October 1st, 2015

Re: NIRB File 03MN107 – AEM response to Information Requests received from Parties regarding AEM's Addendum to the Final Environmental Impact Statement for the Vault Pit Expansion Amendment Proposal for the Meadowbank Gold Mine Project

Figure 1a and 1b: Plan view of exploration drill patterns to determine the lithology and ore-body in Phaser and BB Phaser Pits

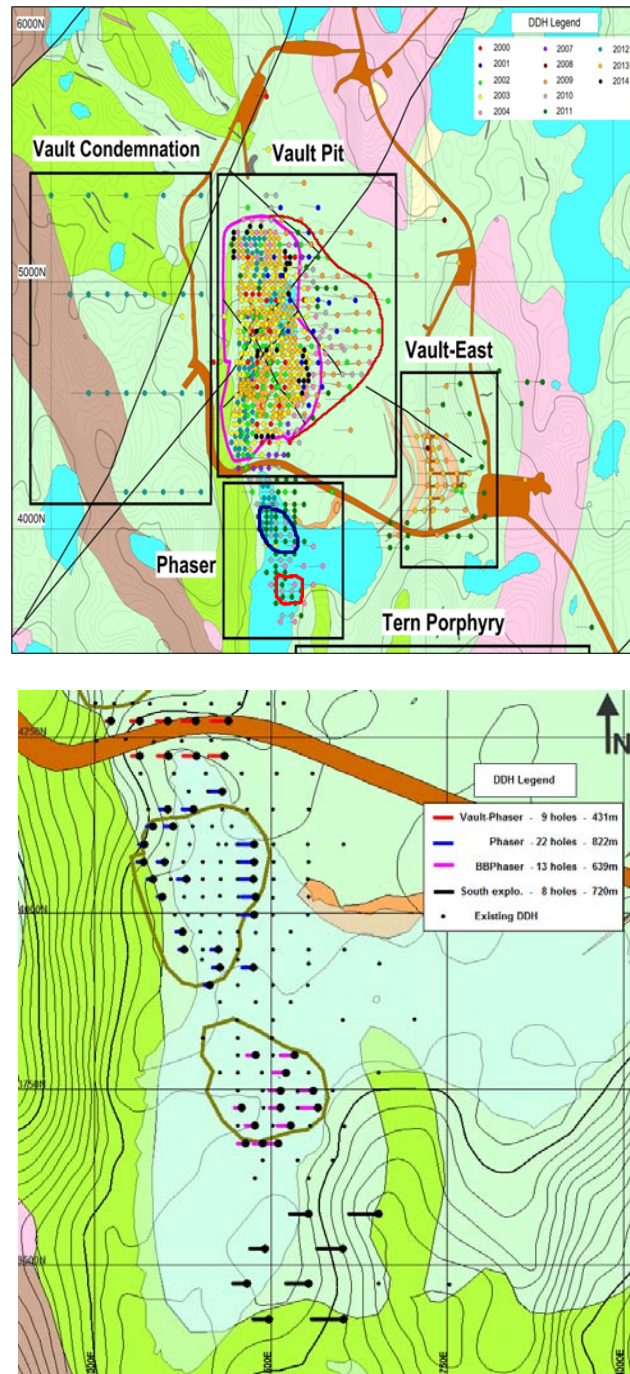
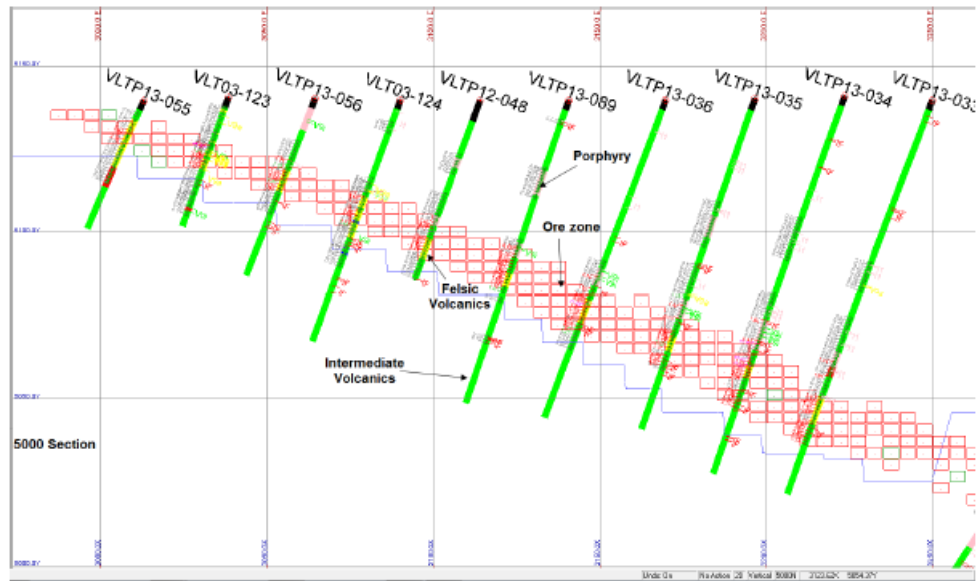
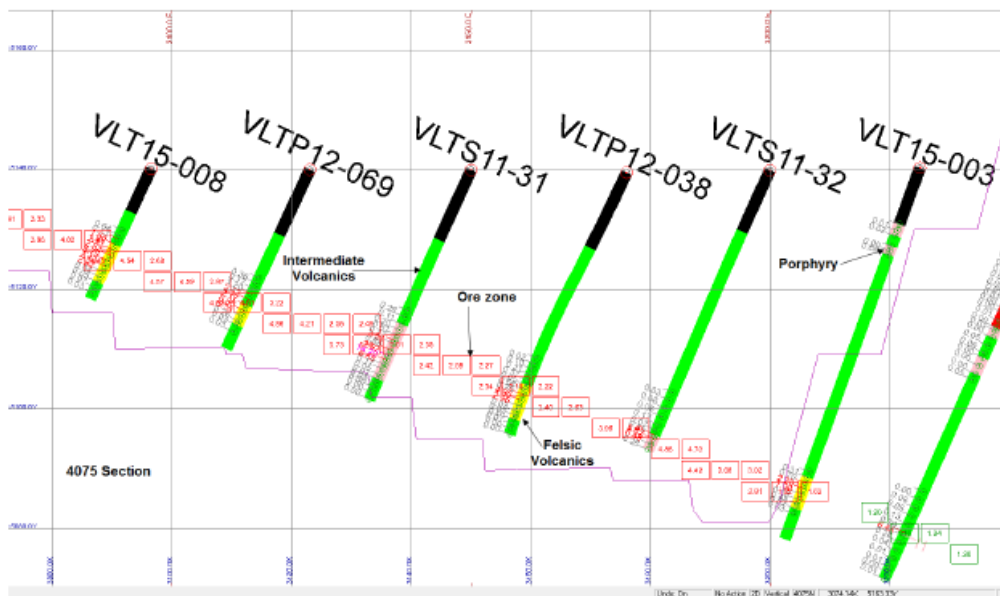
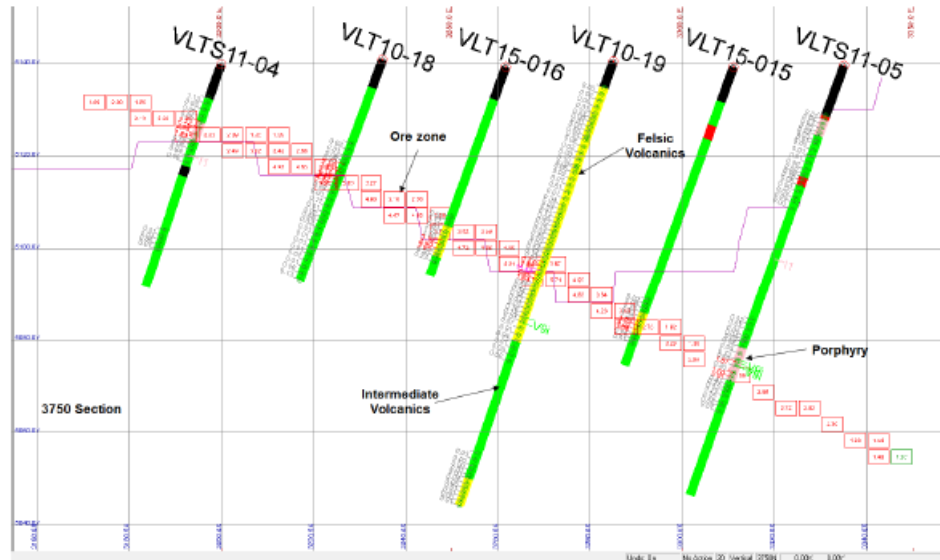
Information Request: Please provide site-specific ABA and ML data from samples within the Phaser and BB Phaser Pits to show distribution of PAG - NPAG within the proposed expansion areas.

As described in Section 4.10.1.1 of the FEIS Addendum, Phaser pit and BB Phaser Pit is an extension of the Vault Pit deposit and is located in the same lithology of the Vault deposit. Figures 1 and 2 below present the current block model presenting the lithological summaries of the Vault Pit, Phaser Pit and BB Phaser Pit deposit.

As part of the feasibility process, AEM has a thorough understanding of the lithology for the purposes of block modelling, pit design, economical modelling and operational planning. Furthermore, up to date operational data from the Vault deposit was recently compared to static test database collected by Golder during project start-up (“Vault Static Test Database (Golder, 2005)”) in order to recommend a minimum sulphur cut-off concentration to be used to identify material that is non PAG for future operation of the Vault Pit; this cutoff will be extended for the Phaser Pits and BB Phaser Pits. The NPR values for both datasets were compared to test the fit of both data sets and to determine the total sulphur content at which material may be considered as potentially acid generating per MEND (2009).

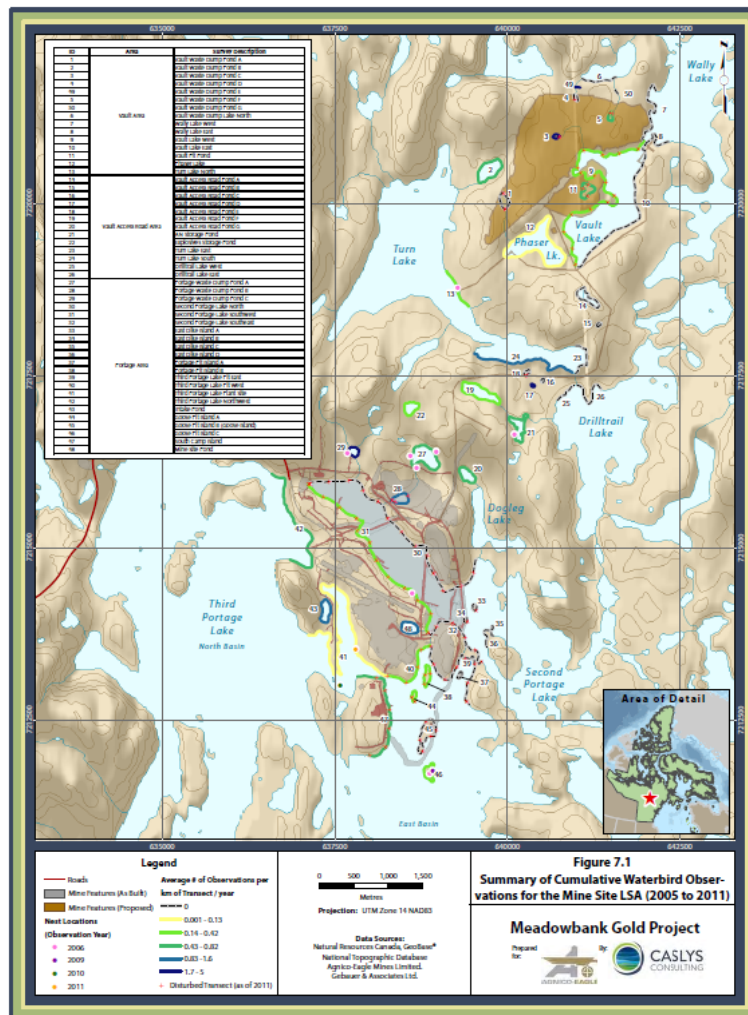
-EC requests that the Proponent provide a detailed description of the extent of migratory bird monitoring (specifically waterbirds) at Phaser Lake; including survey dates, methodology, observations, maps, etc.

As described in the EIS addendum, one Common Loon was observed in 2005 on Phaser Lake. No water birds were subsequently observed in that area (see the Figure below taken for 2005-2011 observation summary. No additional observations were made in 2012).
